150 Richmond Street Final Plan Summary

Note: this parcel is also known as Lot 402 (aka Lot 3 of former Parcel 25)

I-195 Redevelopment District Commission Meeting
January 18, 2023

Site Plan

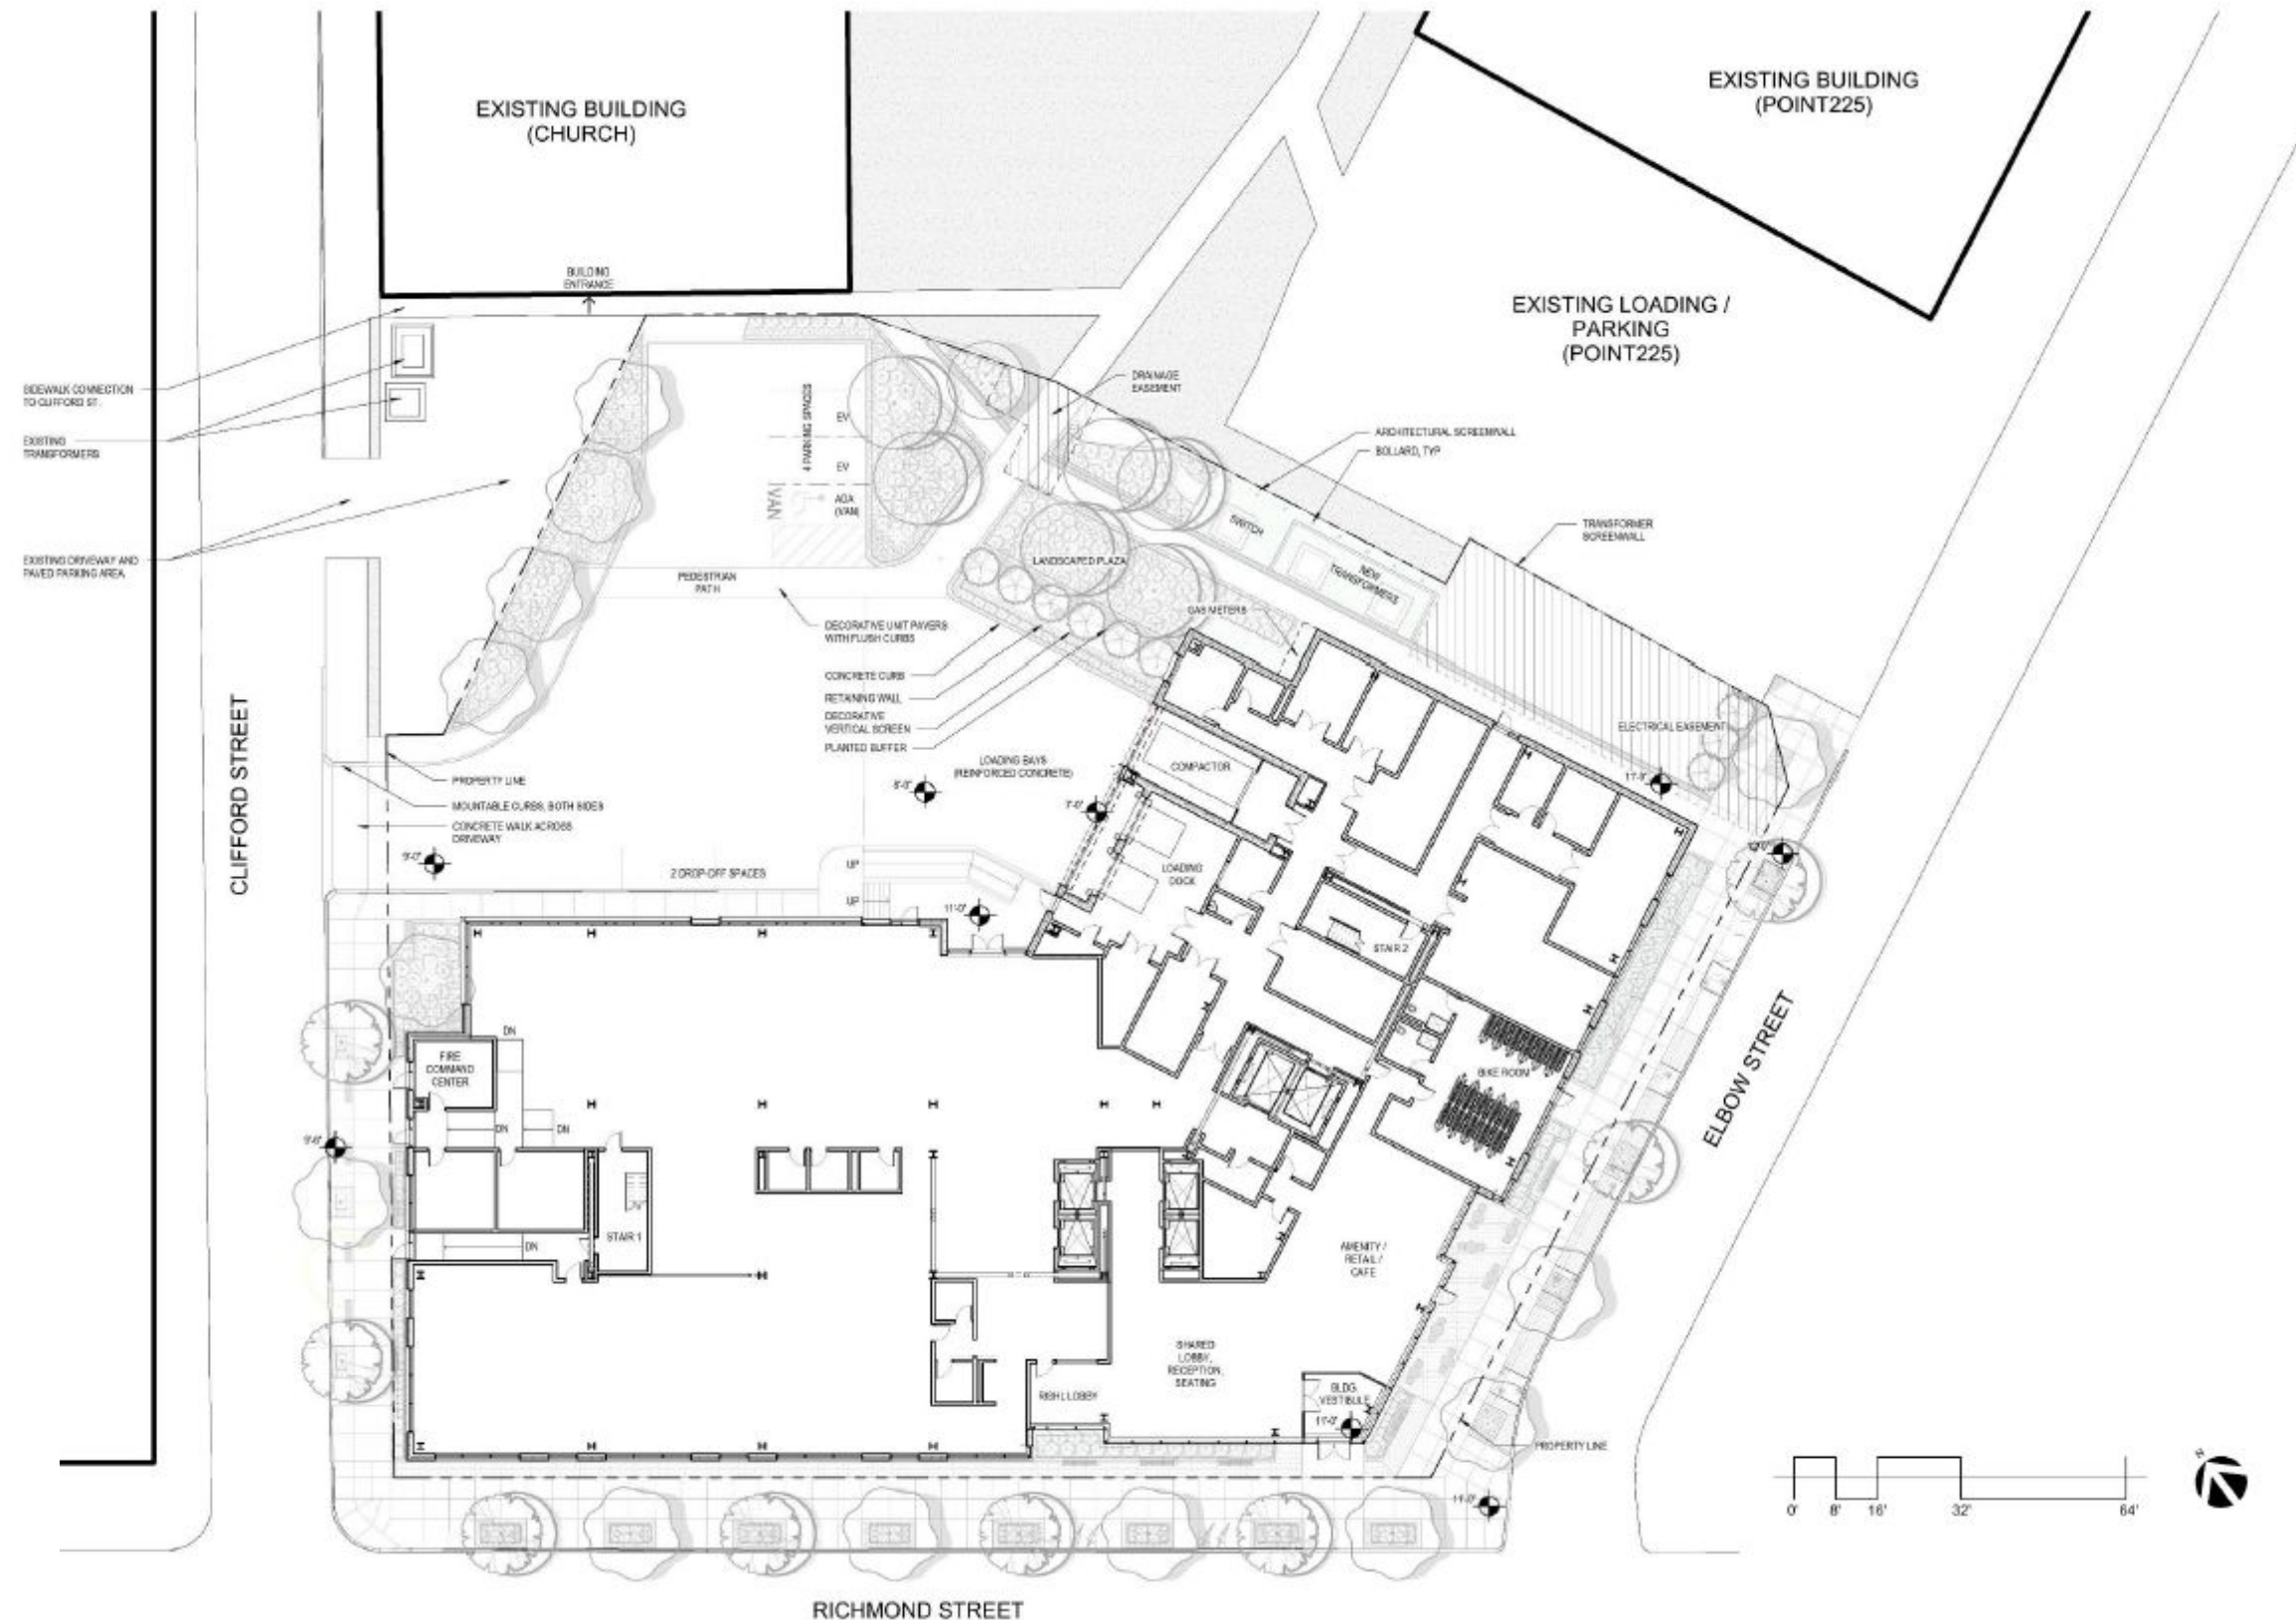
Summary of Changes:

- Sidewalk design refined with street trees, areas of impervious and pervious paving, seating and planting.
- Loading and parking areas are refined to provide improved separation between pedestrian and vehicular circulation.
- Improved visual buffering of loading area
- Reduced curb cut off Clifford Street.

Facade Material Palette Comparison

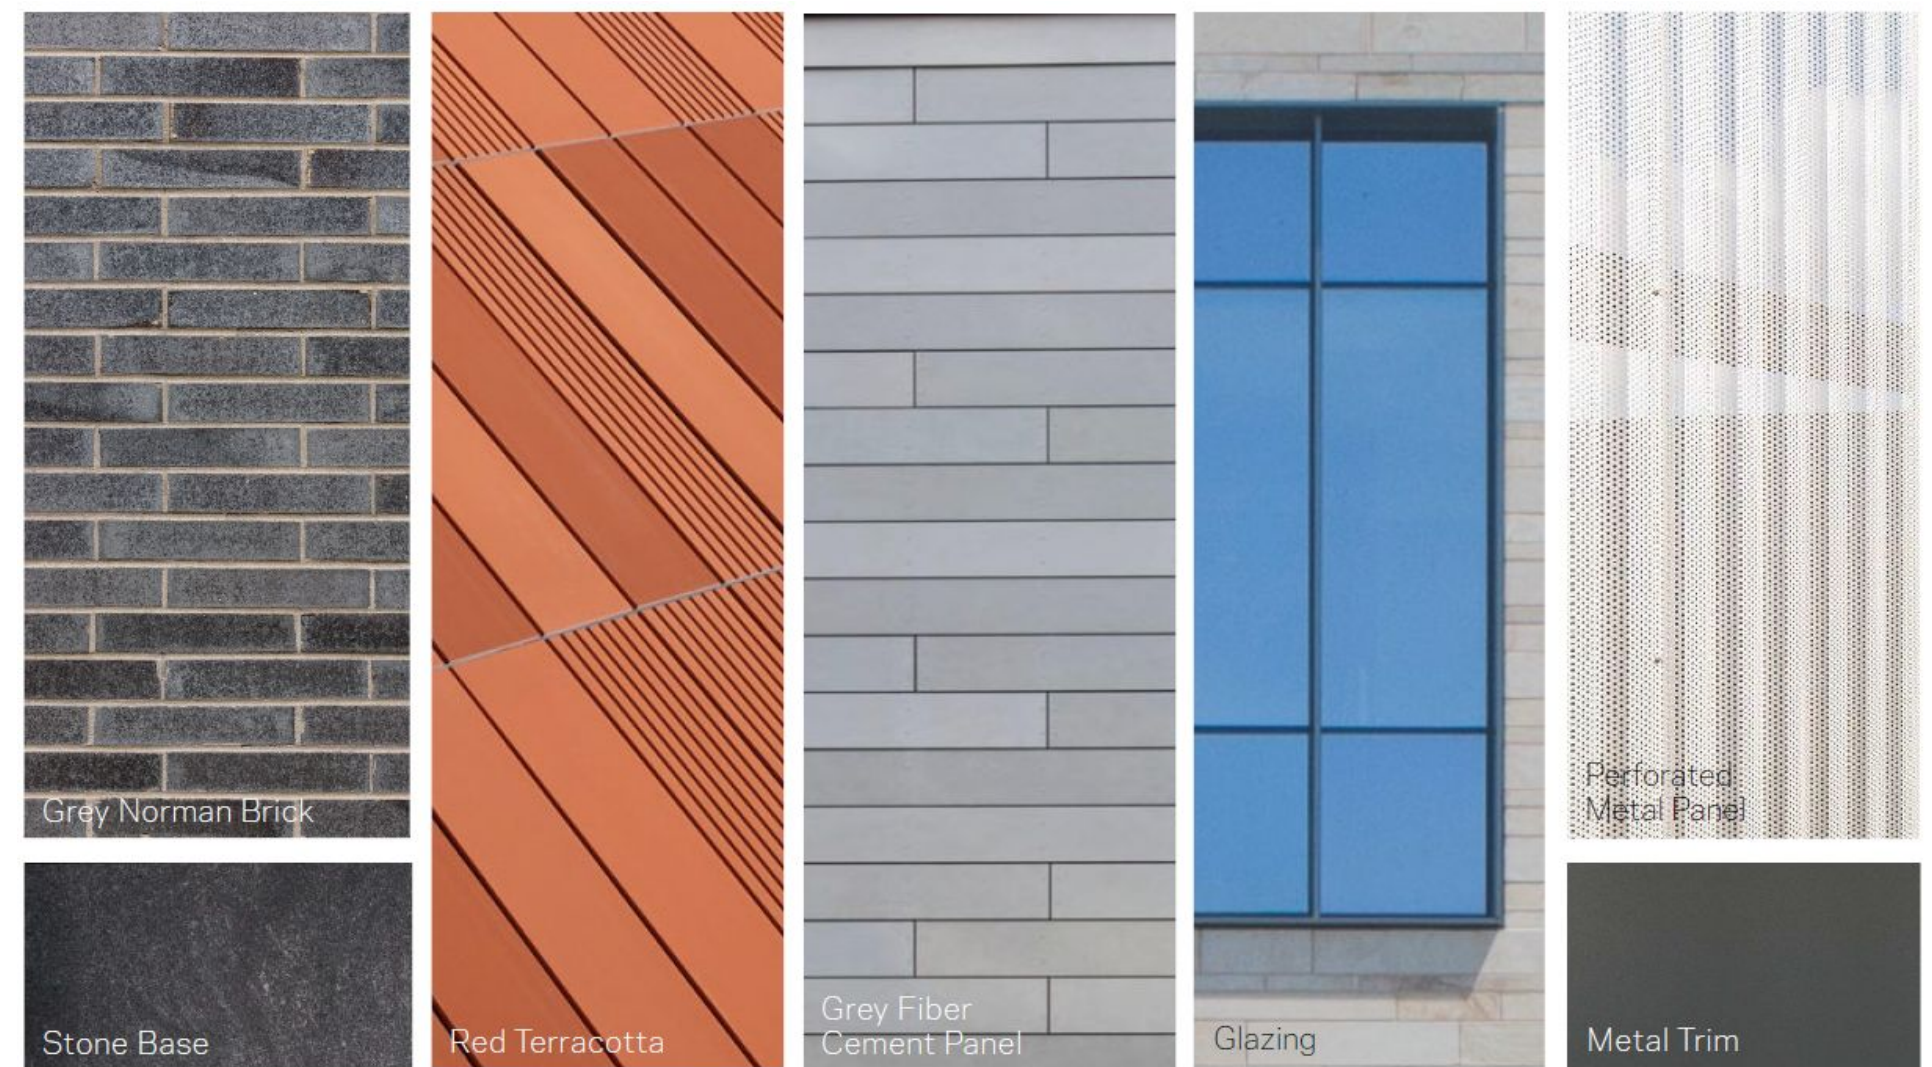
Concept Plan Facade Material Palette (Nov. 2022)

Final Plan Facade Material Palette

Facade Changes

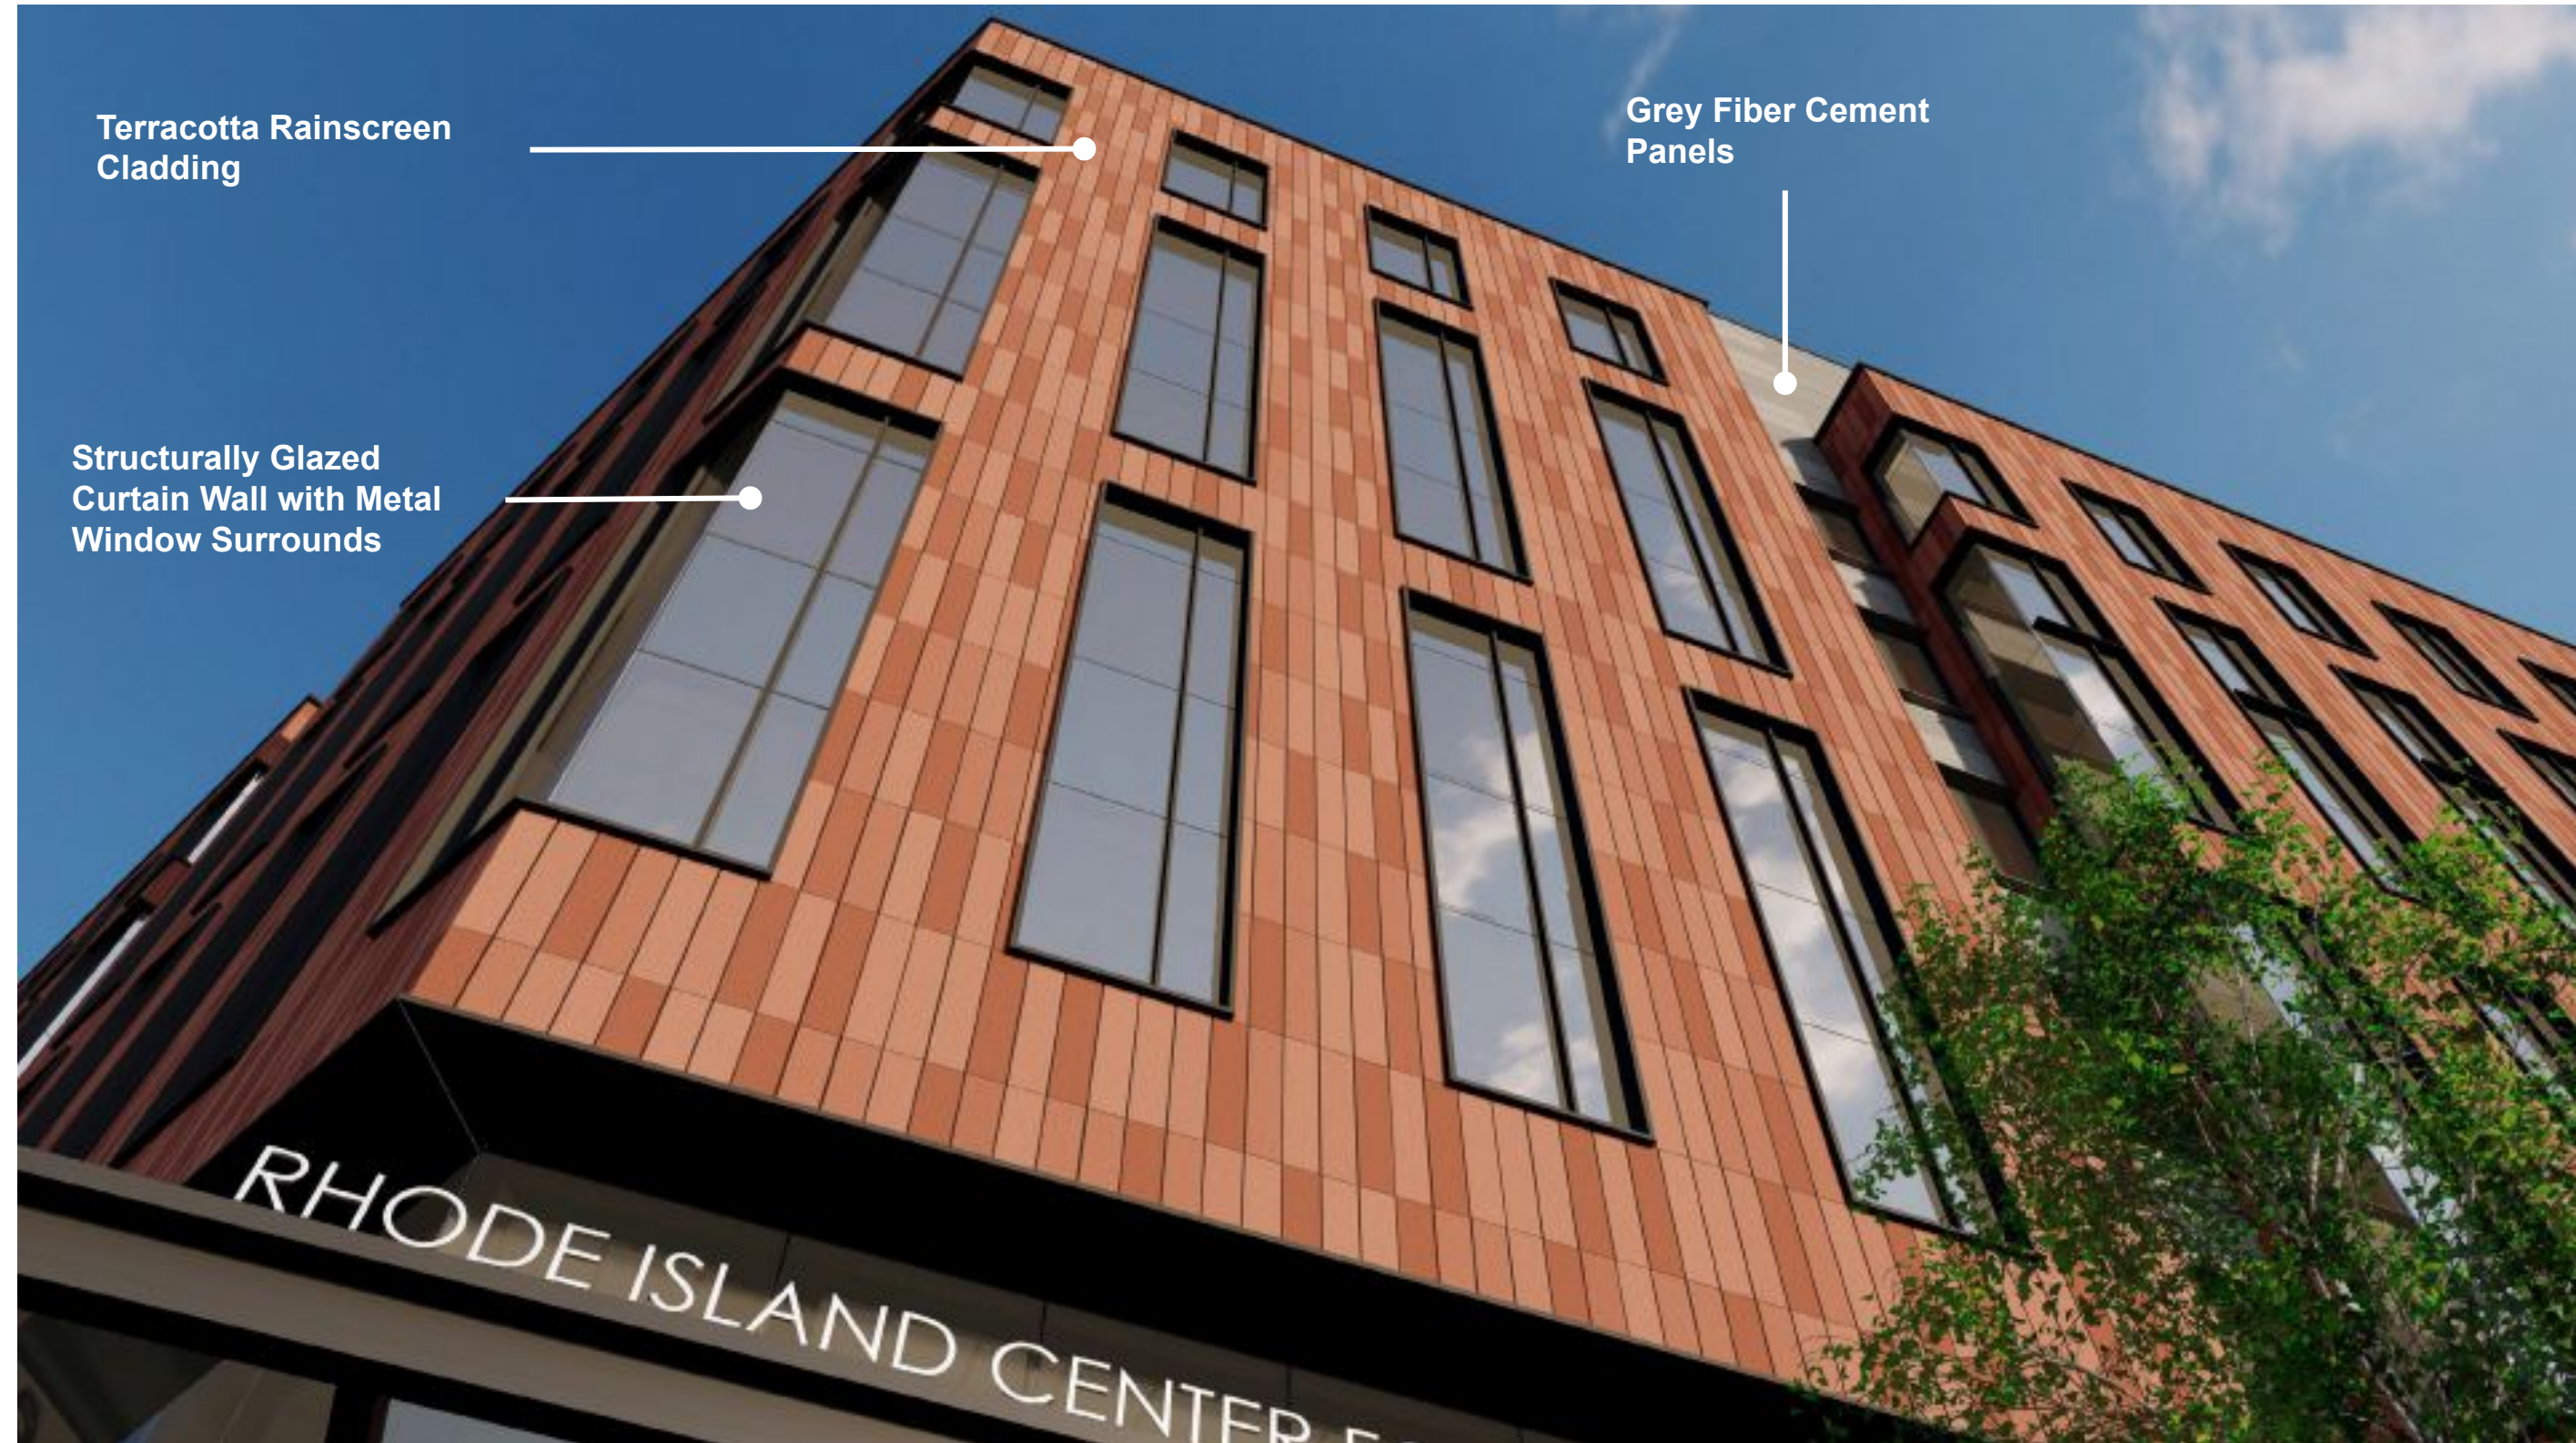
- Terracotta façade utilizes planar panels of 3 different textures to achieve variation in lieu of deeper dimensional profiles
- Angular projections omitted from window surrounds, projecting beyond face of terracotta by 3”
- Variation provided in grey fiber cement cladding to add visual interest

Elevations

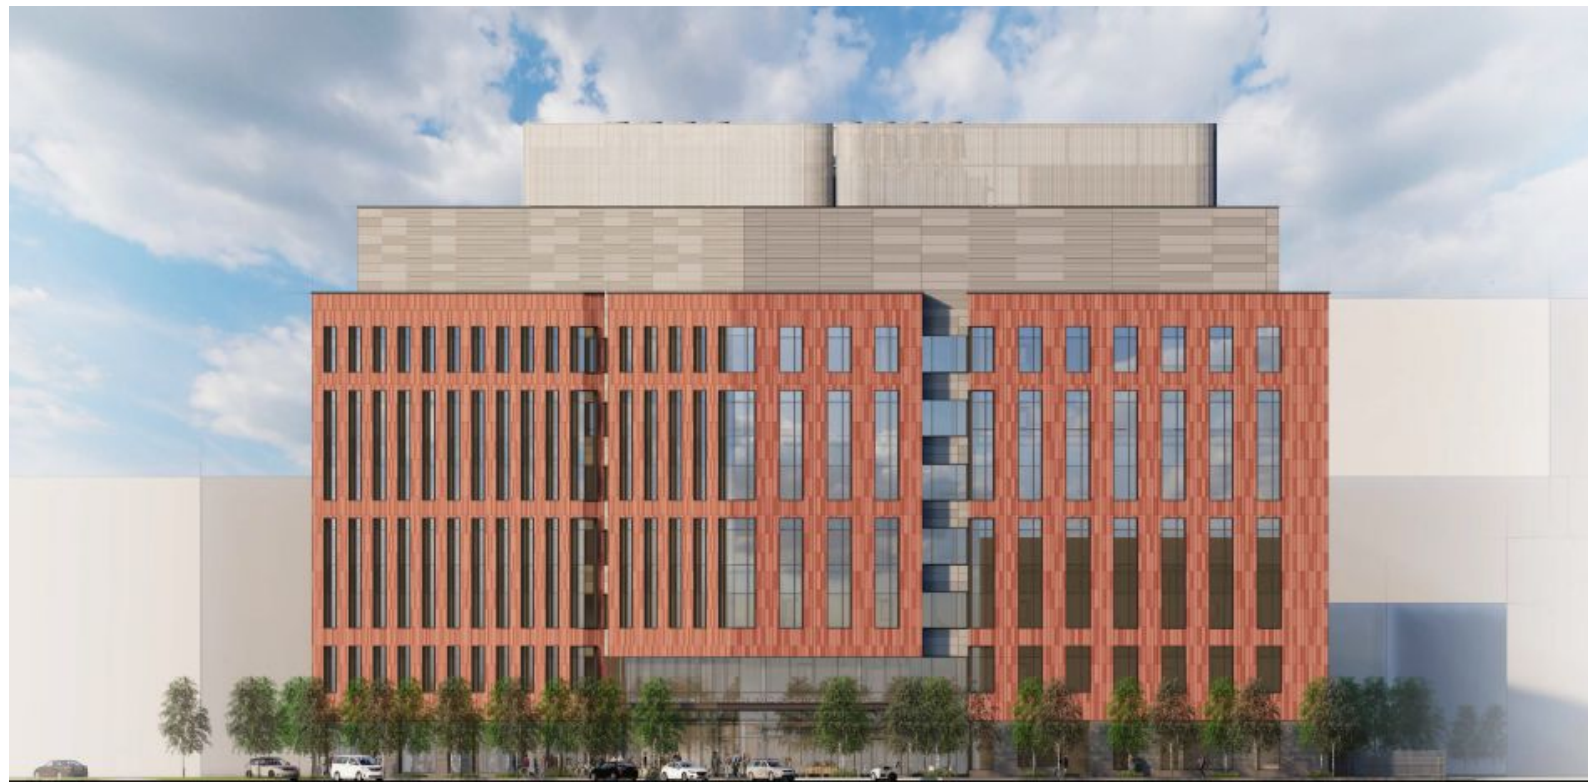
Mechanical Louvers

Mechanical Louvers
